**HUDSON RIVER PCBs REASSESSMENT RI/FS
RESPONSIVENESS SUMMARY FOR
VOLUME 2A: DATABASE REPORT
VOLUME 2B: PRELIMINARY MODEL CALIBRATION REPORT
VOLUME 2C: DATA EVALUATION AND INTERPRETATION REPORT**

DECEMBER 1998

**U.S. Environmental Protection Agency
Region II
and
U.S. Army Corps of Engineers
Kansas City District**

**TAMS Consultants, Inc.
Limno-Tech, Inc.
TetraTech, Inc.
Menzie-Cura & Associates, Inc.**

Figure 27. PCB DNAPL transport study fluorescent particle mass balance.

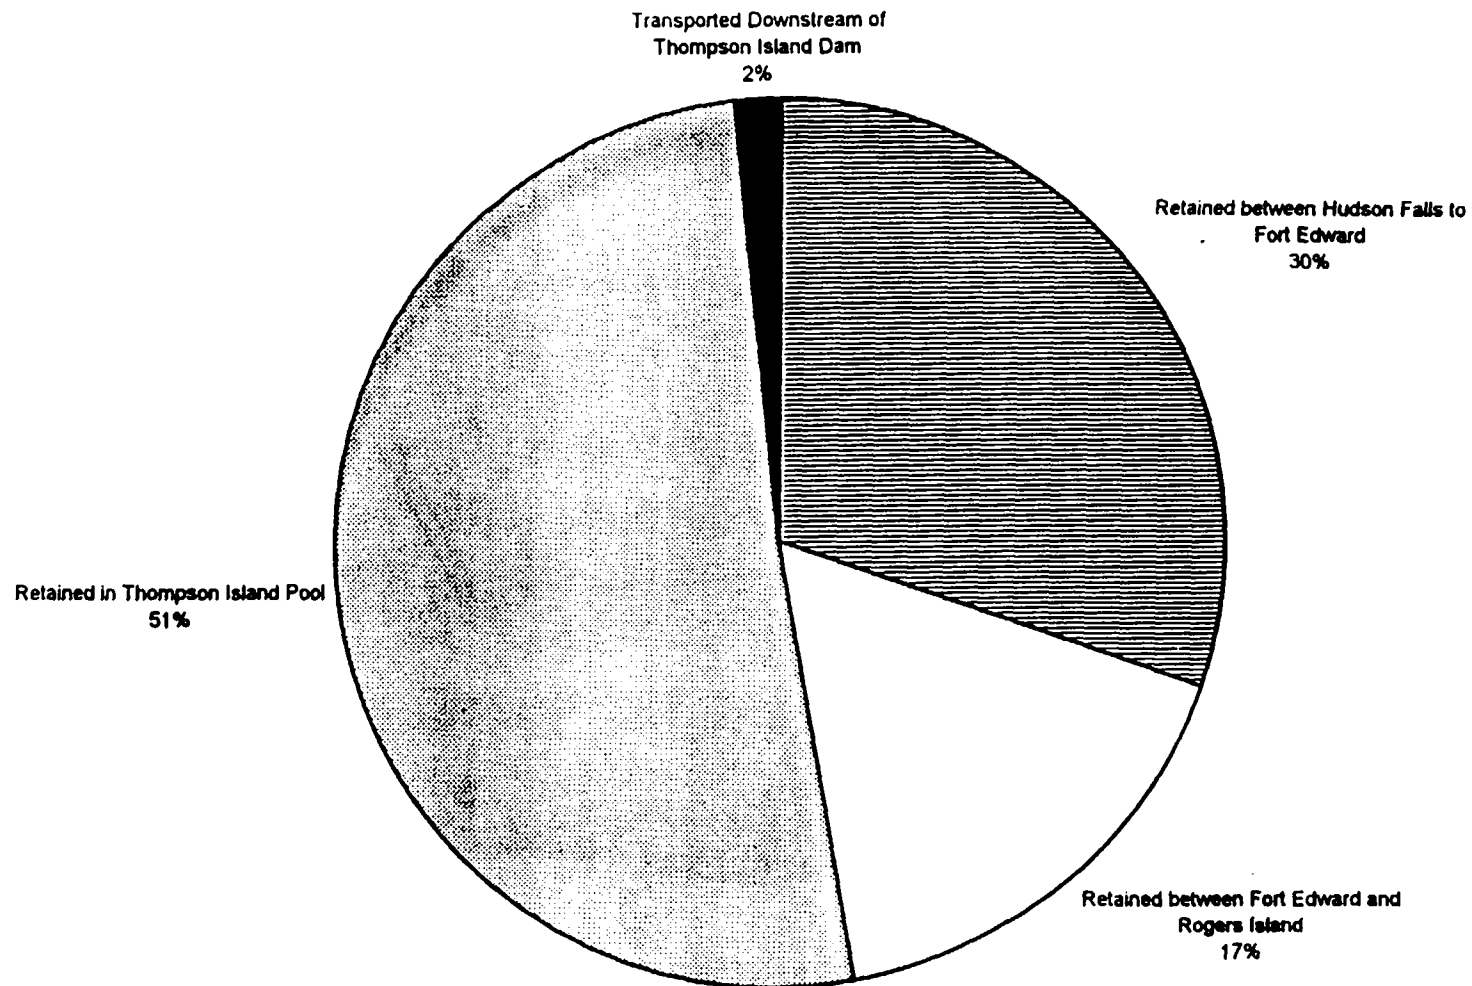
downstream of the TID (Figure 27). To the extent that these fluorescent particles simulated DNAPL transport, these data suggest that DNAPL originating from Hudson Falls is largely retained within the river upstream of the TID. Moreover, preliminary analysis of fluorescent particle size distribution data indicates that particles with an average diameter of approximately 100 *um* constitute the majority of the mass of particles retained within the Hudson Falls to Fort Edward reach of the river. These larger particles were not transported downstream under the flow conditions during the study (est 800-8000 cfs) suggesting that oil droplets with mean particle diameter of greater than approximately 100 *um* are retained near Hudson Falls at flows less than 8,000 cfs and are likely transported downstream during higher flow periods. Additional analysis of these data is underway, and a full report will be submitted to EPA.

Figure 28. Predicted average June-August 1993 Hudson River PCB loading profile (river mile 195 - 155).

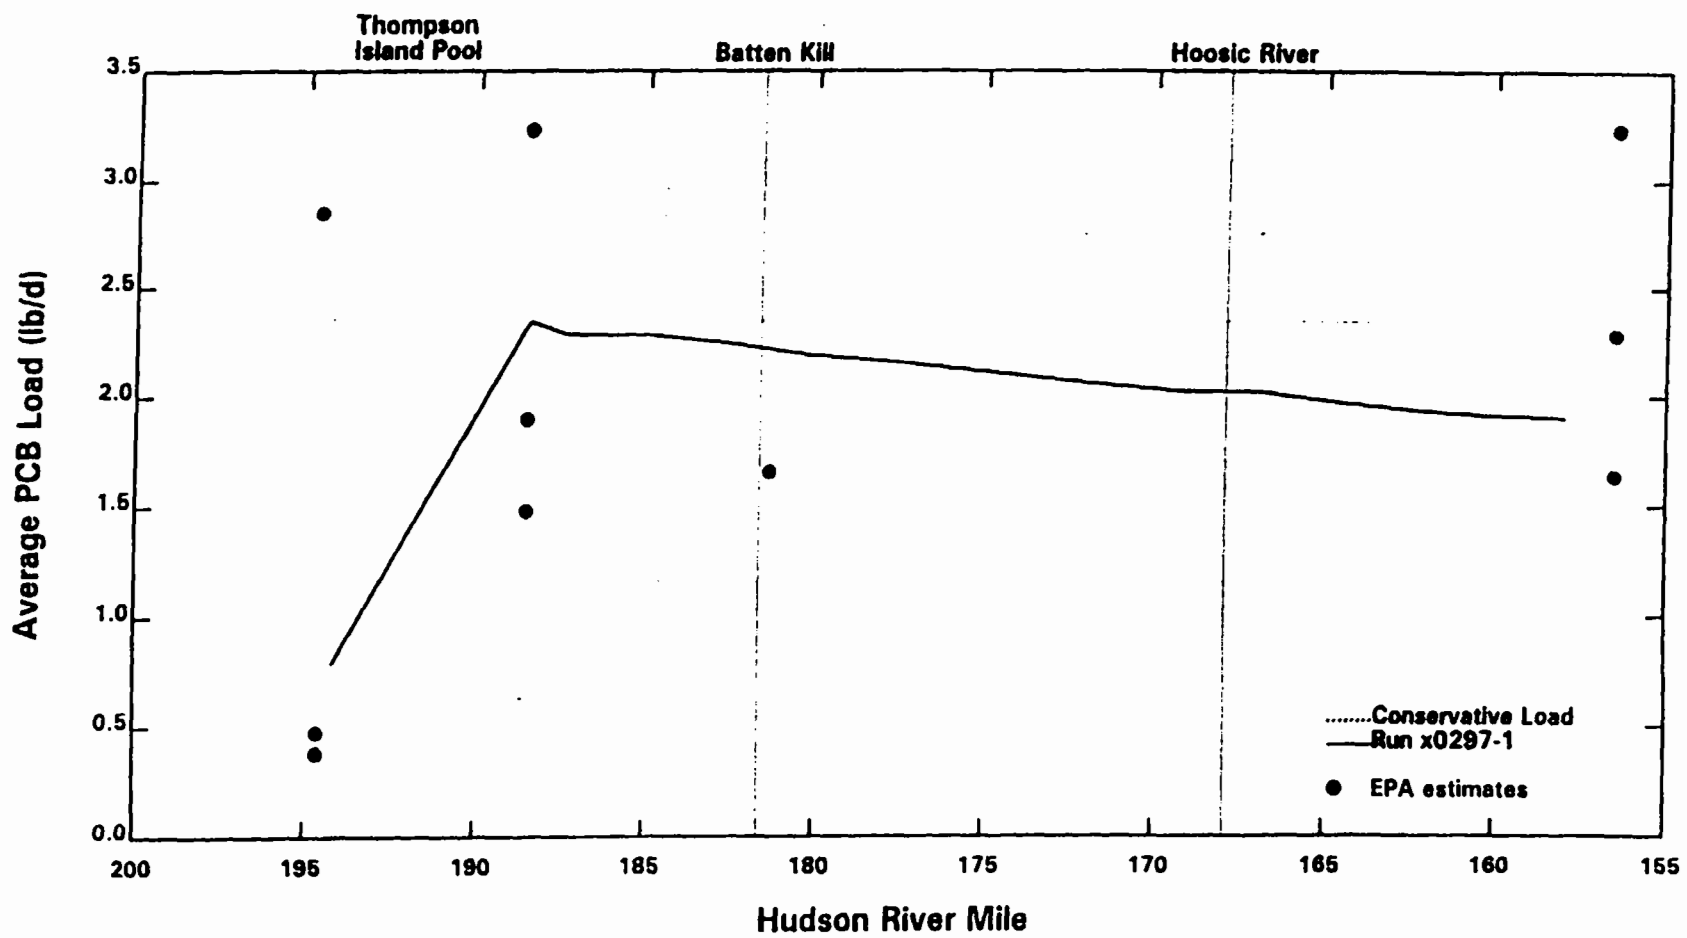
Figure 28 compares the three EPA estimates of loading through the Upper Hudson River for the June to August 1993 period with the model simulation for the same period. The dashed-line profile represents the conservative transport of PCBs that EPA claims exists from the TID to Troy. The model shows a 19% loss of PCBs in the downstream direction that is the net result of volatilization, net deposition of solids and sorbed PCBs, and the addition of PCBs to the water column from downstream sediments and, to a lesser degree, by downstream tributary inputs. This net loss is small enough to be within the uncertainty bounds of the data. The EPA data collection in the summer of 1993 found an approximately 20% increase in the PCB load between the TID and Waterford. This was a period during which the increase in the PCB load across the TIP reflected the impact of the Allan Mill release. Conditions downstream of the TID may also have been influenced by the same event.

Figure 29. Predicted settling and volatilization components of average June-August 1993 Hudson River PCB loading profile (river mile 195-155).

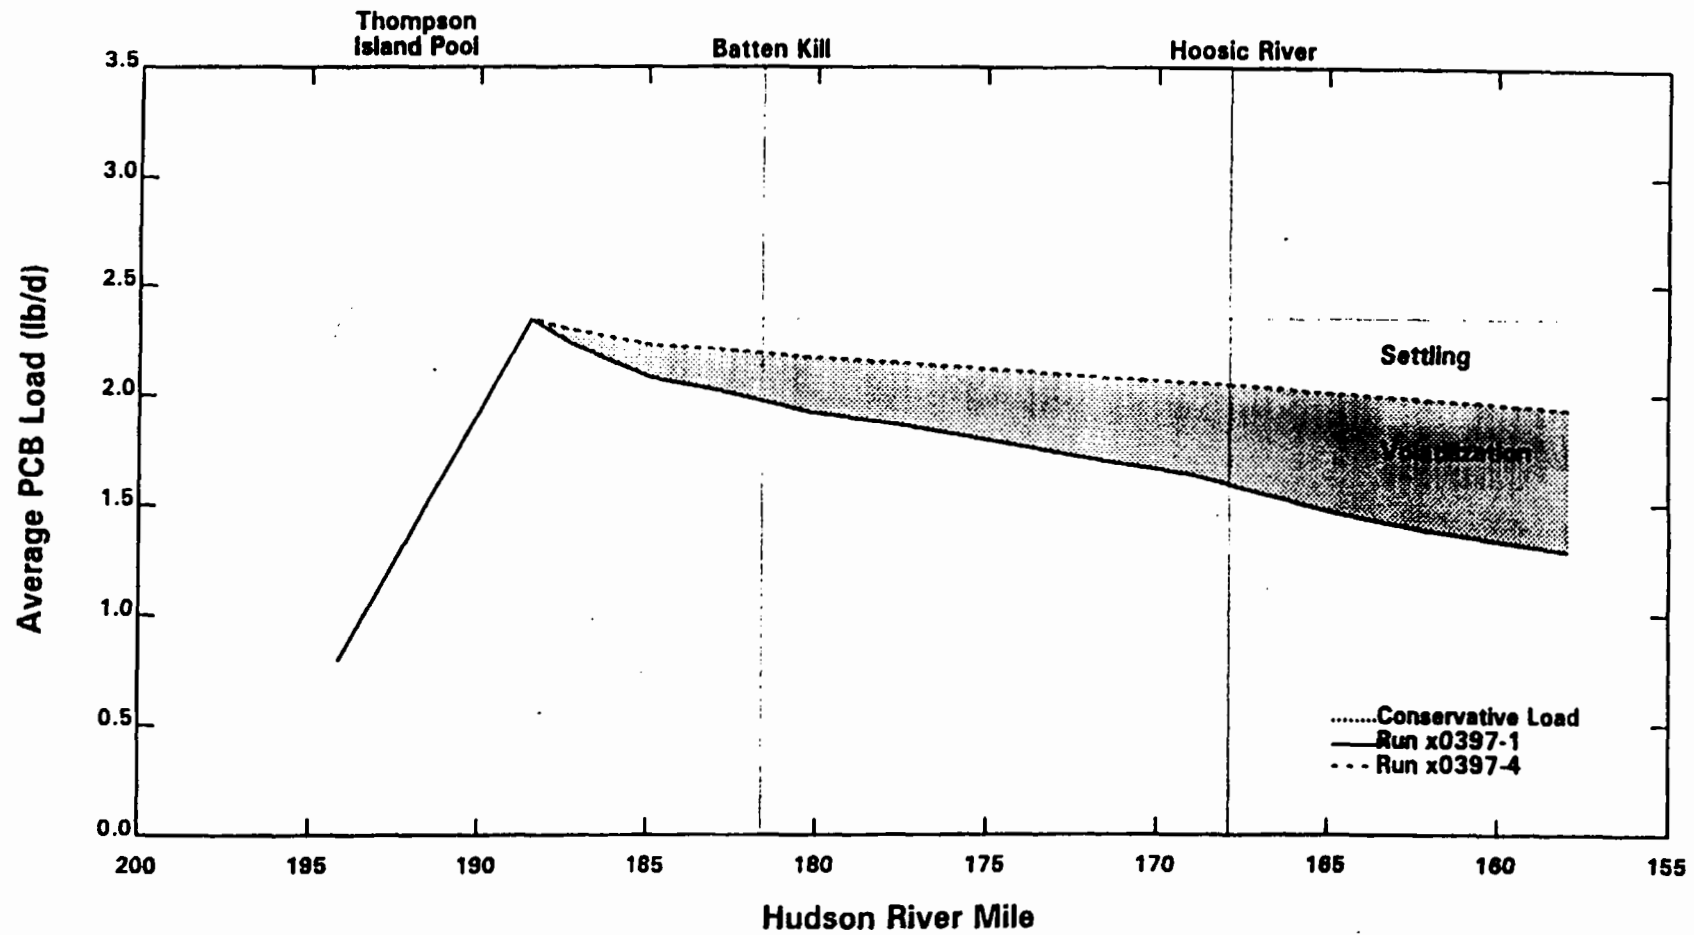
Figure 29 provides further clarification of the origins and fate of the TID PCBs in the river during this period. Here, the lower limit of the shaded region represents the profile of water column PCB load without a sediment source in Reaches 1-7. PCB load in the river decreases by 45.1% between Thompson Island Dam and Waterford. This decrease is a result of the combined effects of settling (the unshaded region, 17.4%) and volatilization (the shaded region, 27.6%). Considering the results of Figures 28 and 29 together, the sediments in Reaches 7 - 1 contribute 32.3% to the

Figure 30. Absolute amount of chlorines removed from PCBs as a function of concentration.

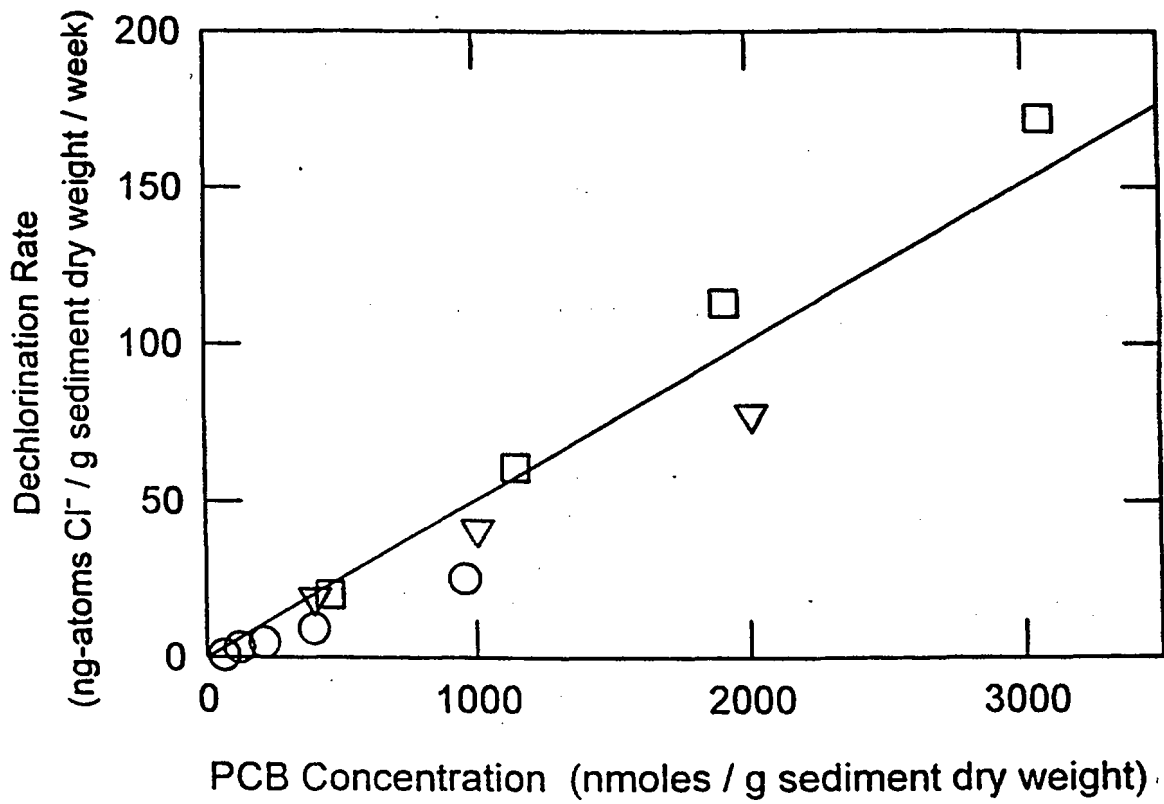
Numerous studies in the laboratory and the field have detected anaerobic PCB dechlorination over a broad range of concentrations (reviewed in Bedard and Quensen, 1995). Figure 30 shows that anaerobic PCB dechlorination has been observed in controlled laboratory studies at concentrations as low as 10 ppm (Abramowicz *et. al.*, 1993; Fish, 1996, Rhee *et. al.* 1995). Taken together, the studies demonstrate that there is a linear relationship between PCB concentration and dechlorination rate without a threshold concentration.

Figure 31. Intra-homologue PCB dechlorination peak ratio as a function of PCB concentration.

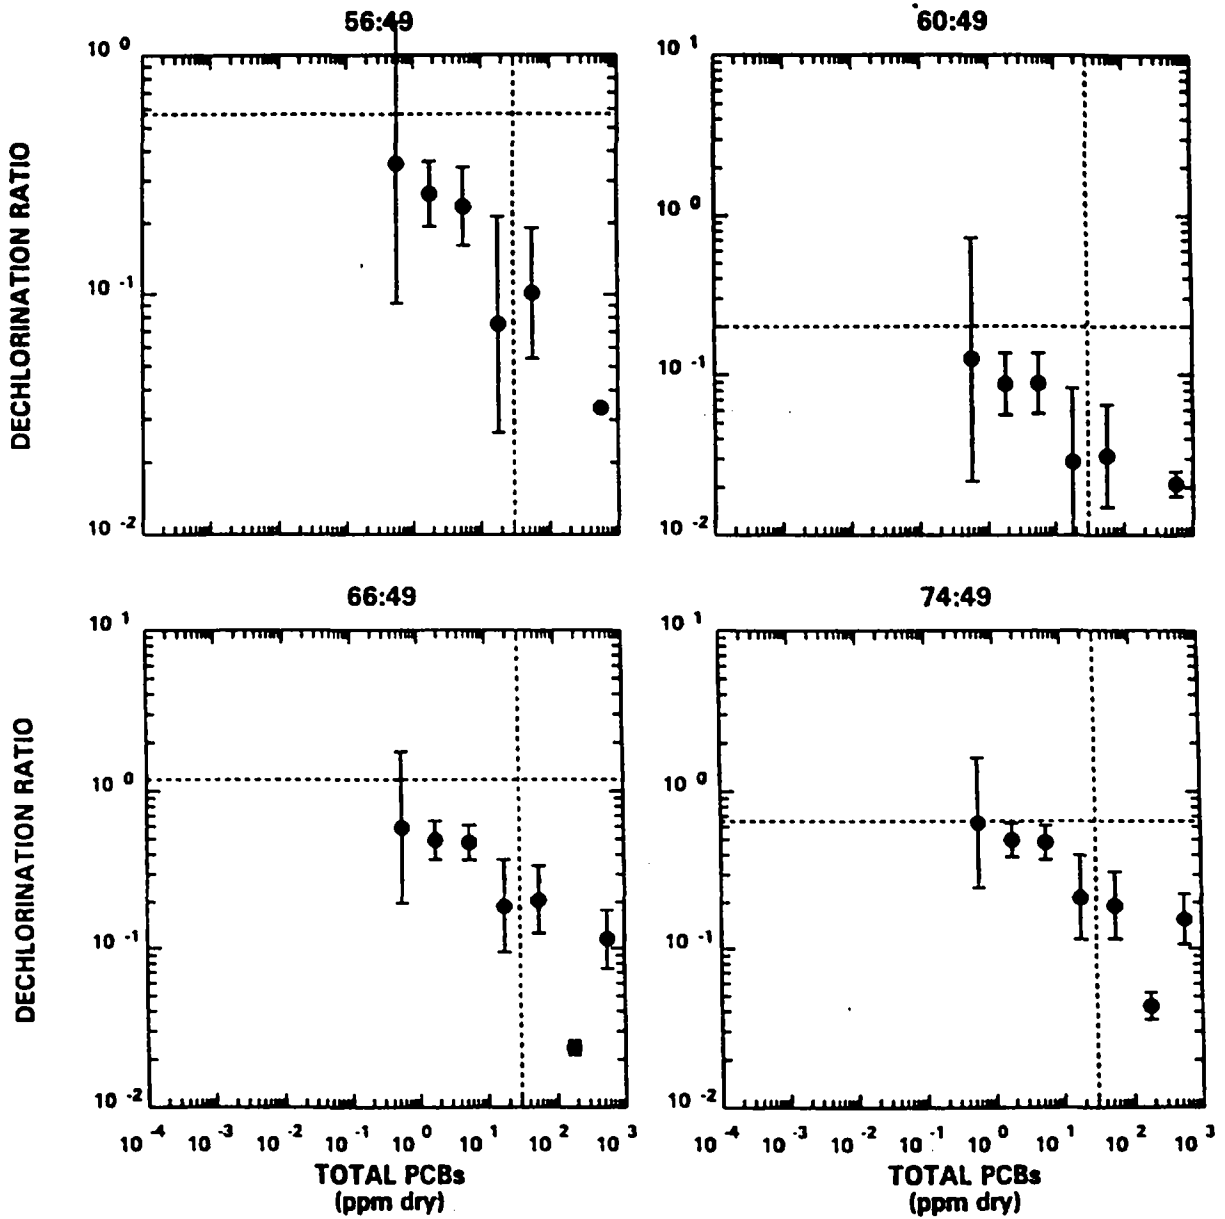
The use of intra-homologue peak ratios to assess dechlorination at various PCB concentrations is shown in Figure 31. Four peak ratios are utilized (BZ 56/49, 23-34-/24-25-CB; BZ 60/49, 234-4-/24-25-CB; BZ 66/49, 24-24-/24-25-CB; BZ 74/49, 245-4-/24-25-CB). These ratios represent the change in the dechlorination sensitive tetrachlorobiphenyls (mono-*ortho* substituted) to the more resistant tetrachlorobiphenyl congener 24-25-CB (di-*ortho* substituted). The result of this peak ratio analysis demonstrates that significant dechlorination occurs at all concentrations, even at sub-ppm levels. There is also a clear trend demonstrating more extensive dechlorination at higher PCB concentrations, consistent with laboratory experiments.

Figure 32. Intra-homologue PCB dechlorination peak ratio as a function of sediment depth for core segments with total PCB less than 30 ppm.

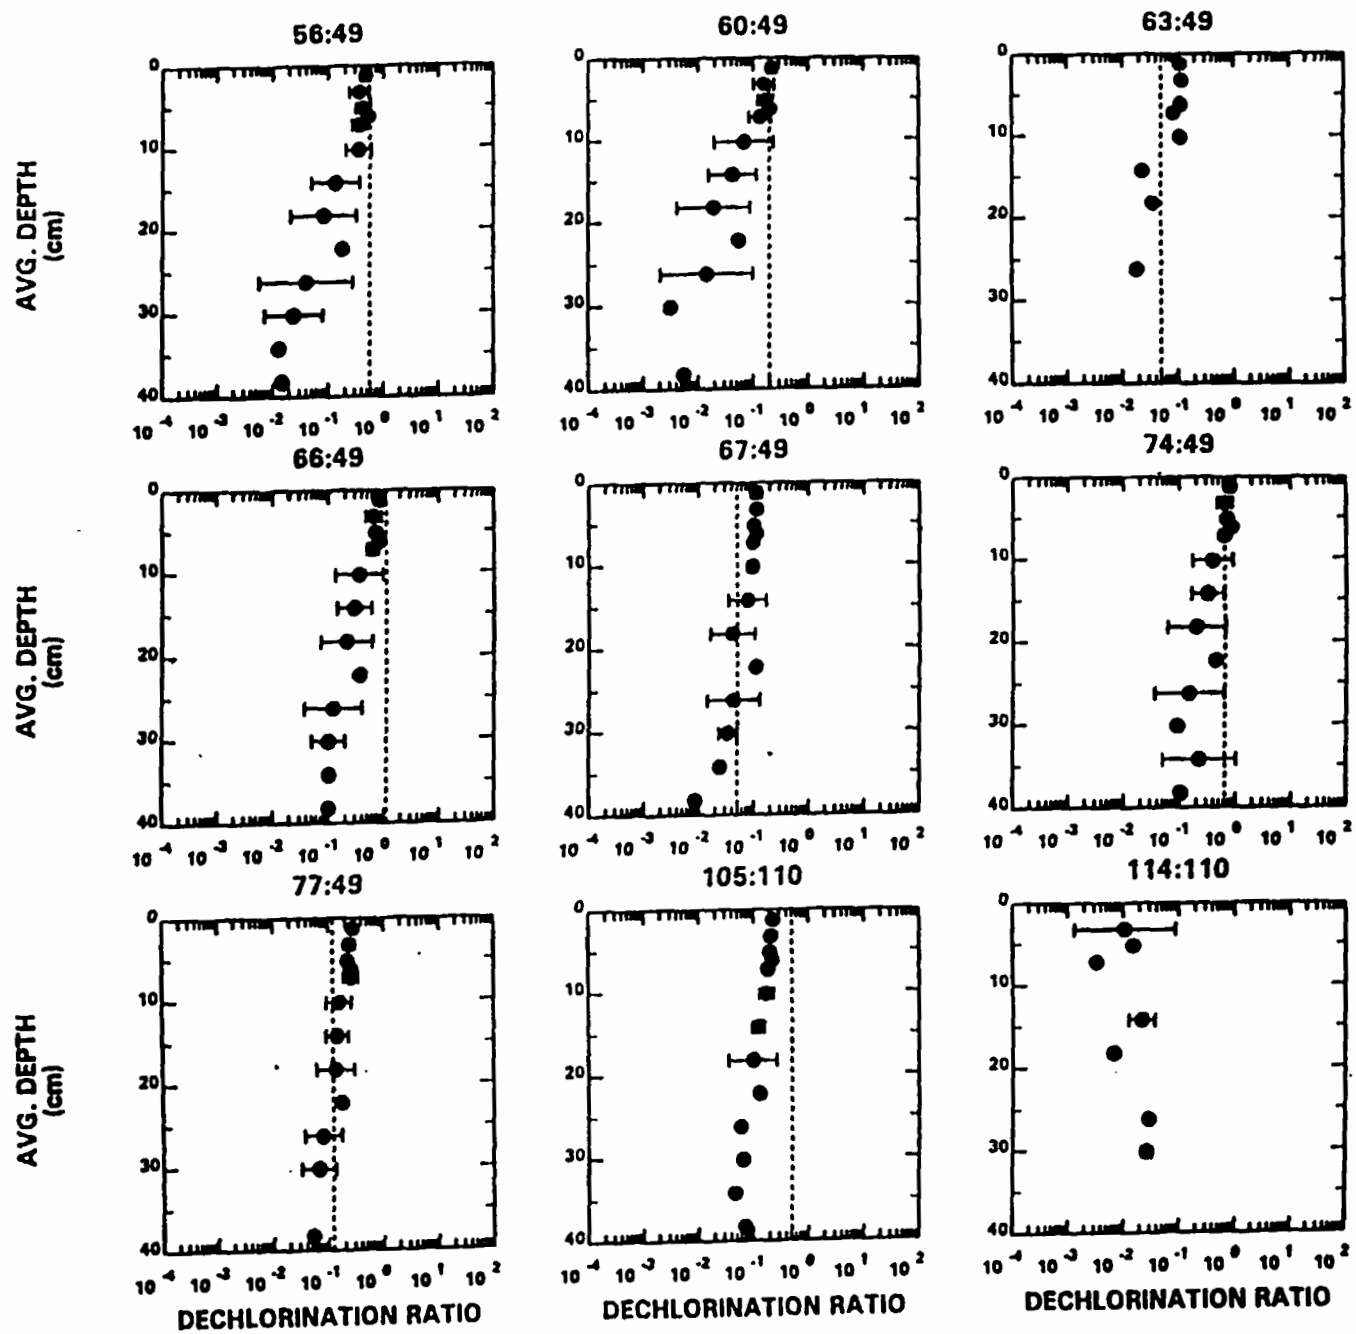
Additional evidence to demonstrate that dechlorination is still occurring in the upper Hudson is found in Figure 32. This Figure represents the application of the intra-homologue peak ratios to the EPA Phase 2 high resolution sediment cores. To minimize the impact of concentration on the rate of dechlorination, only a narrow concentration range was utilized (all 3-30 ppm core segments from all Upper Hudson high-resolution cores). Note that the extent of dechlorination continues to change in a smooth continuum with increasing depth in the core. This data demonstrates that the extent of dechlorination strongly correlates with increasing depth and increasing age of the sediment,
